**West Sewershed Package 1
Solicitation Number: CO-00196
Job No.: 17-4546**

**ADDENDUM 4
September 19, 2018**

1 ACCESS ROAD IMPROVEMENT PLAN
SCALE: 1" = 400'

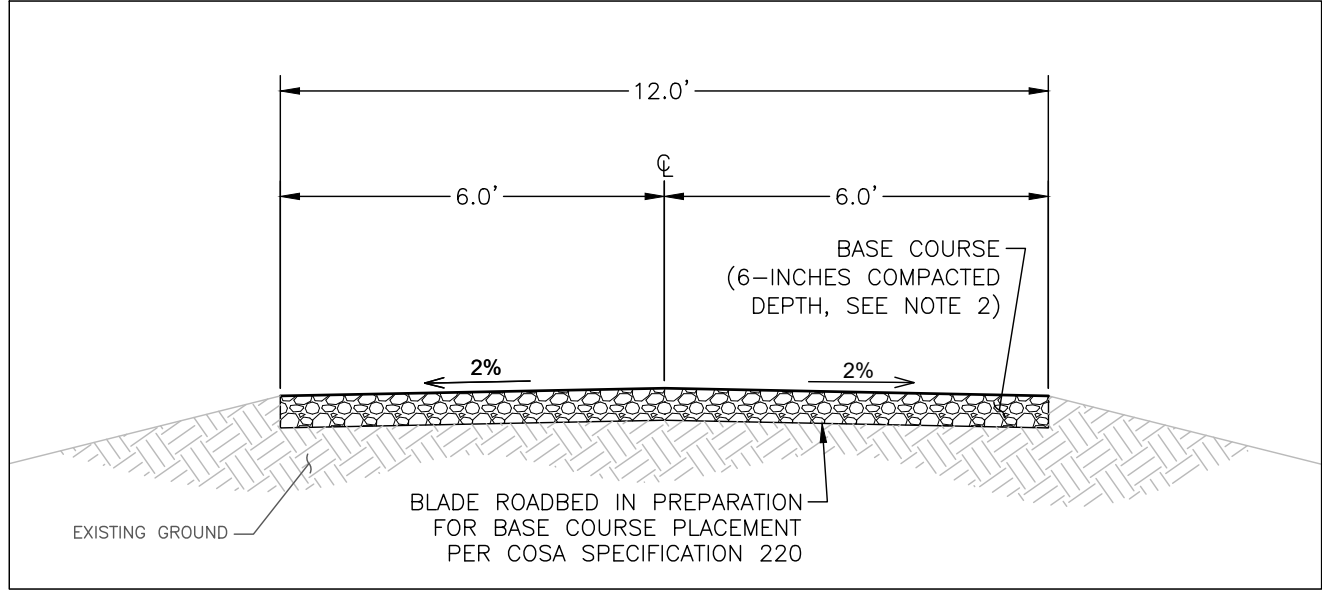
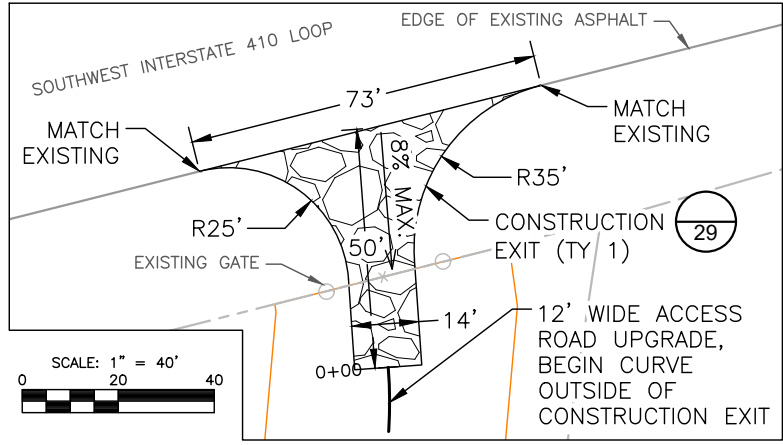
22. **Question:** There are two areas on the project where blading and base course are called out to be performed and placed to establish access roads. One location is called a temporary access road on the drawings, while the other is referred to as an upgrade to an existing road. Will both of these access roads be required to be removed at the completion of the project, or will one or both of them remain as permanent improvements? Please clarify.

Response: The improvements made to the existing gravel road (south of Loop 410) will remain as permanent improvements. Concerning the temporary access road (north side of Loop 410) it is the intent that this temporary access road be removed at the completion of the project. Clarification is also provided on revised Plan Sheet 4 included with this addendum.

DEVELOPER:	SAN ANTONIO WATER SYSTEM		
CONT.	BUDGET PROJ.		
SUBMITTED	_____		
APPROVED	_____		
MAP No.	_____		SHEET 24
SECT. No.	_____		OF 39
DR. RJ	CK. ADW	JOB No. 17-4546

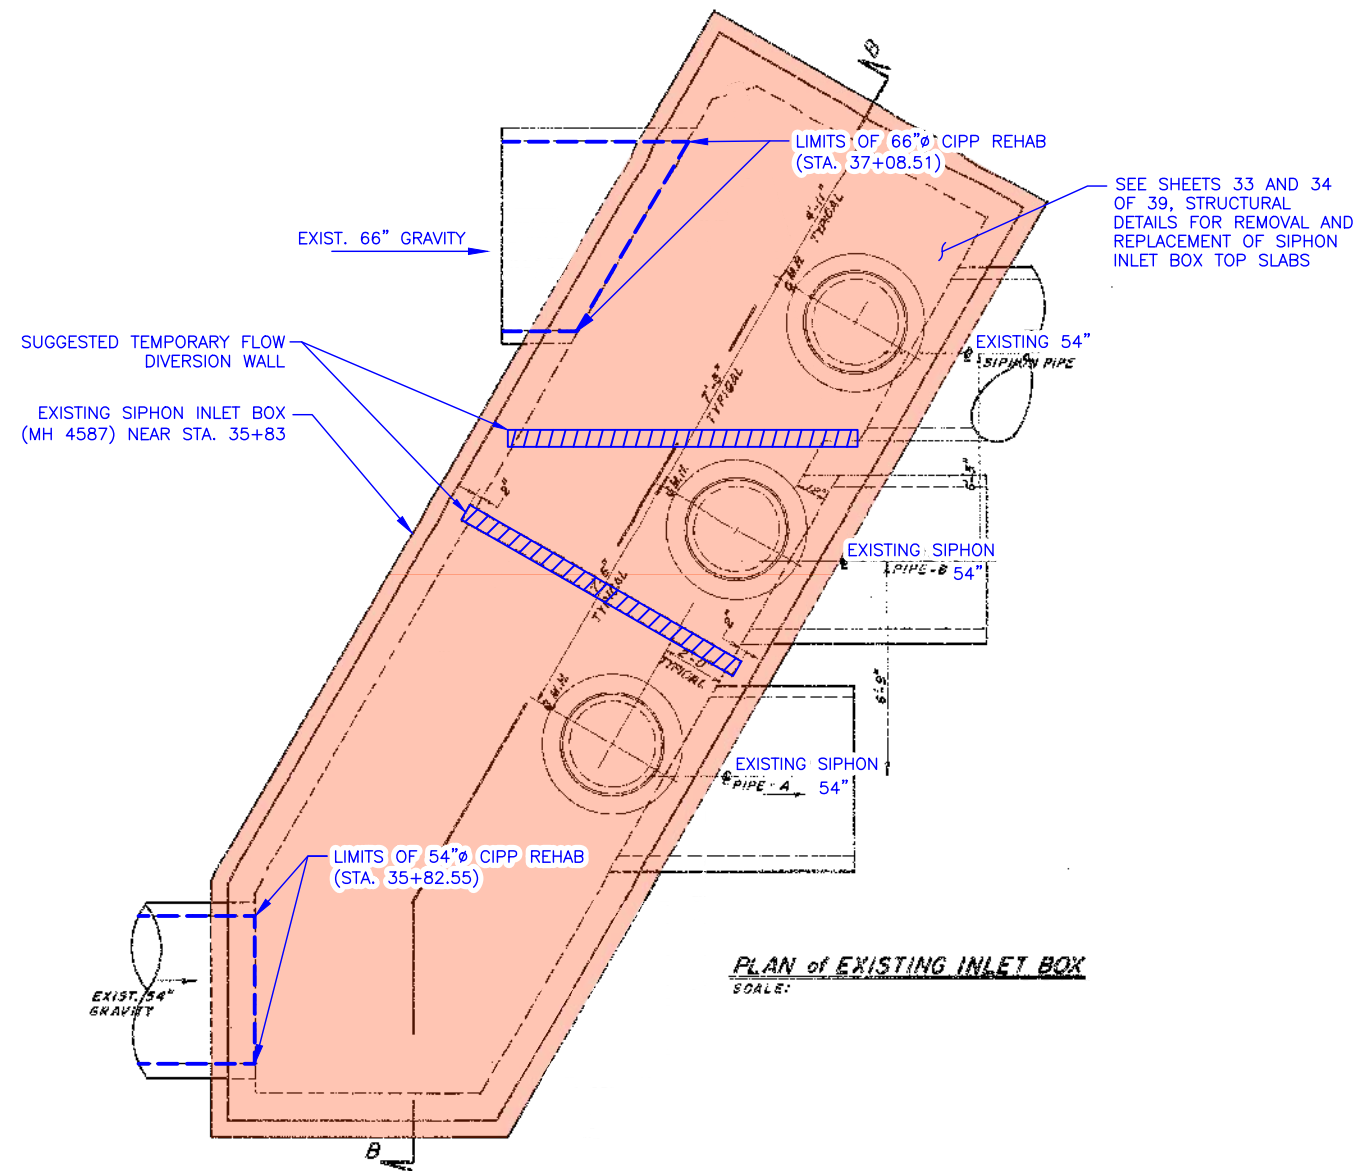
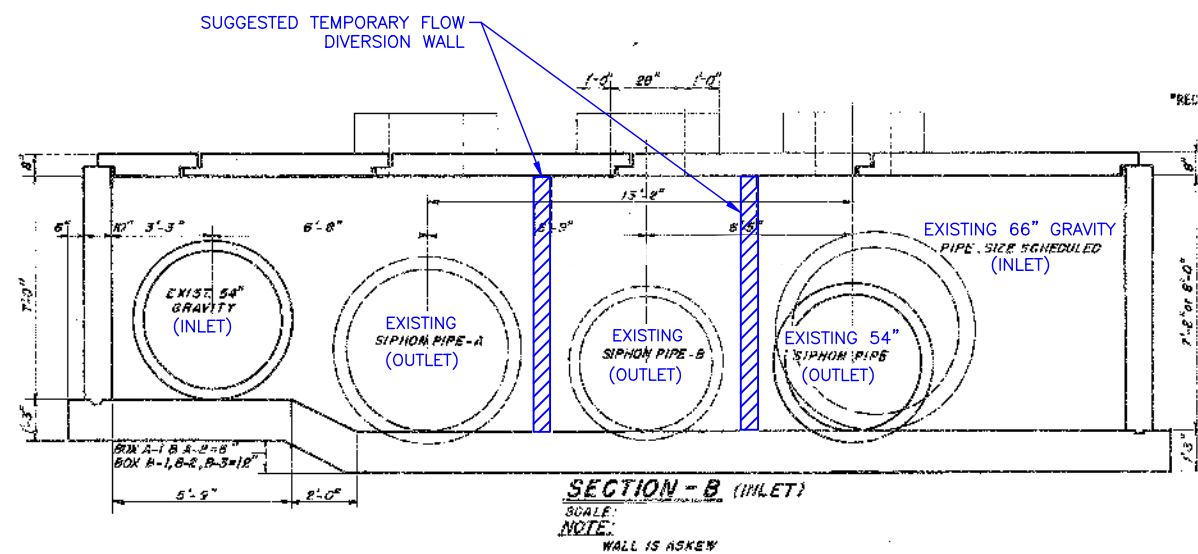
23. **Question:** Drawing sheet 24 shows proposed weir walls that it appears were originally planned to be built in the siphon inlet box (MH 4587), but from our site survey, we were not able to see any evidence of these weir walls existing. In the pre-bid meeting, it was mentioned that they were indeed constructed in the structure. Is there any information on their current condition - are they still viable? If the weir walls do still exist, do they need to be removed? The bypass plans reference building temporary flow diversion walls within this structure. Will these temporary walls be required to be removed at the end of the project? Will any permanent walls be required to be built in this structure for this project?

24. **Question:** The details of the siphon inlet box (MH 4587) on drawing sheet 24 show a 4th pipe exiting that structure that is called out as a gravity 54" pipe, but this pipe is not shown exiting this structure on the Engineering Plans. Does this gravity 54" pipe exist in this structure, and if so, what is its alignment after leaving the structure?

Response: We agree that no evidence can be seen to indicate that weir walls currently exist in the siphon inlet box (MH 4587). If weir walls or portions of weir walls exist, they shall be removed by the Contractor. Temporary flow diversion within the structure will be required to be removed at the end of the project by the Contractor. No permanent walls are required to be built within the siphon inlet box for this project. Plan sheet 24 has been revised to provide additional clarification and is provided with this addendum.

Response: There is not an existing fourth (4th) 54" pipe exiting the siphon inlet box (MH4587). The 54" pipe called out on the detail is the 54" gravity line entering the structure. Refer to revised plan sheet 24 that is provided with this addendum for further clarification.

1 SANITARY SEWER STRUCTURE VENT INSTALLATION DETAIL
SCALE: NONE

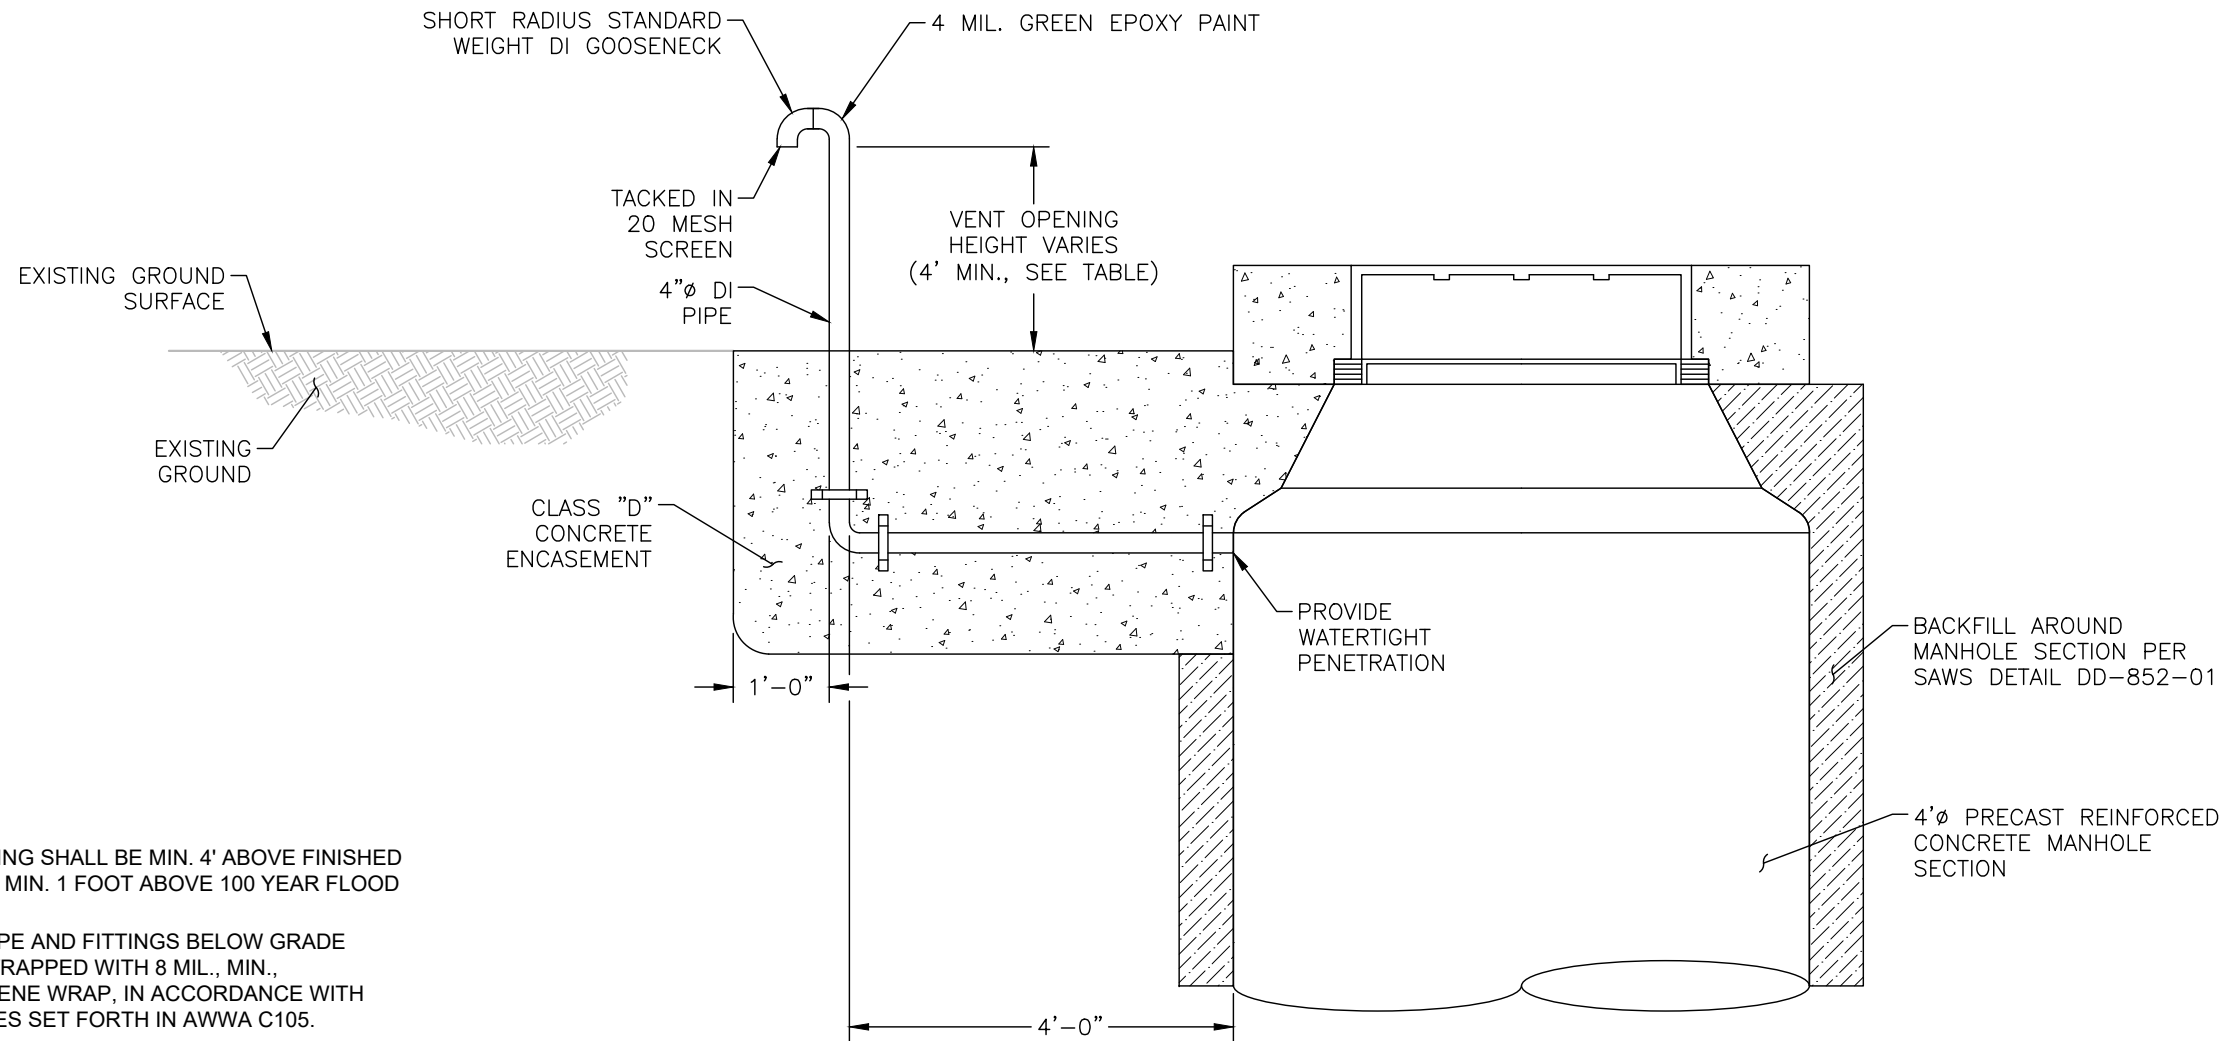
- 18. Question: Where manholes are shown to be reconstructed on drawing sheets 6 – 14, they reference the details on drawing sheets 33 & 34, but per the detail on drawing sheet 35, it appears that most of these manholes will also require a vent to be installed. Should the detail on drawing sheet 35 also be referenced on the Engineering Plan pages at the manholes where a vent is being installed?**

Response: Concerning manholes to be reconstructed, the sheet drawings have been modified by this addendum to include reference to the vent details on drawing sheet 35.

MANHOLE-TYPICAL
SCALE: 1/2" = 1'-0"
(PLAN VIEW)

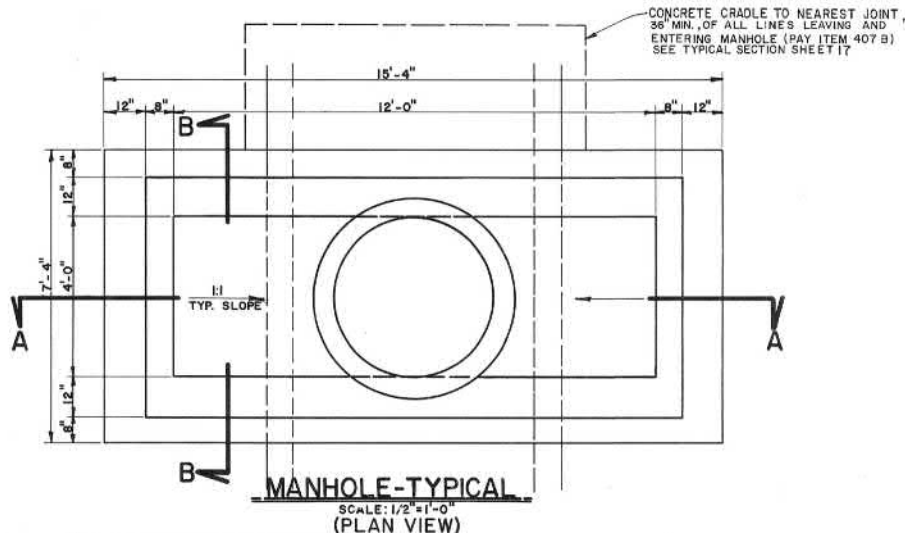
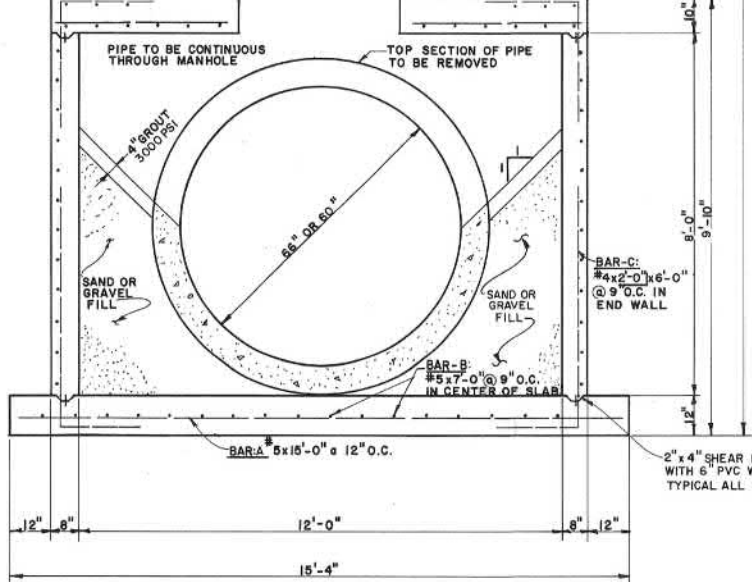
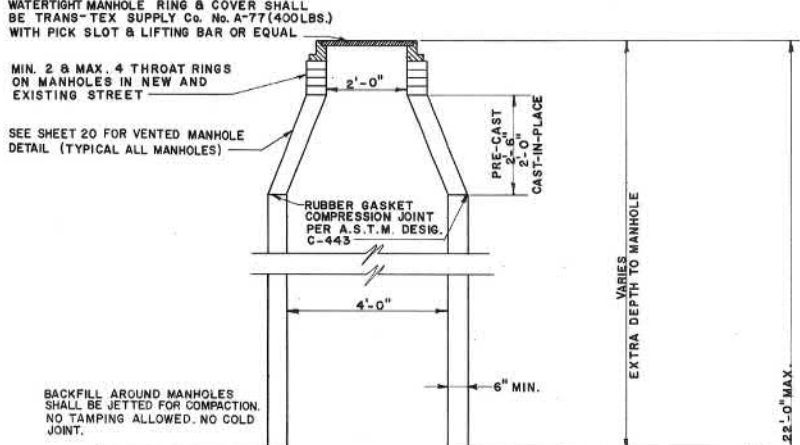
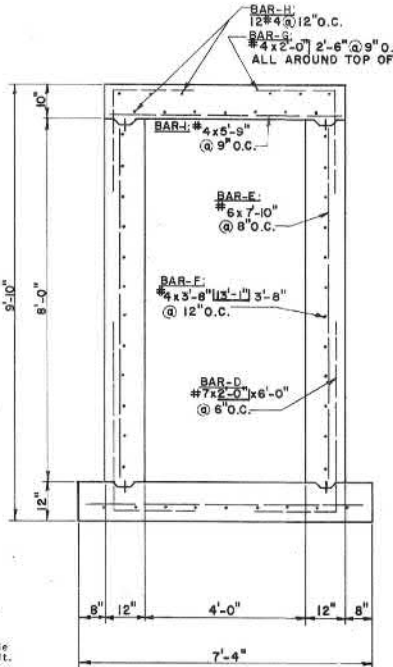
25. **Question:** There is a manhole detail shown on page 48 of the pre-bid presentation document that is not provided in the drawings. If this detail is applicable to the manhole reconstruction work, please provide it as part of the bid documents.

Response: The manhole detail is based on record drawings associated with the 66" sanitary sewer line. Refer to plan sheets 38 and 39 provided with this addendum for the record drawing associated with the manhole detail associated with the 54" and 66" sanitary sewer lines. The manhole detail in the pre-bid presentation is not part of the contract documents and Bidders should only reference plan sheet 38 and 39 with this Addendum to assist in preparing a bid.
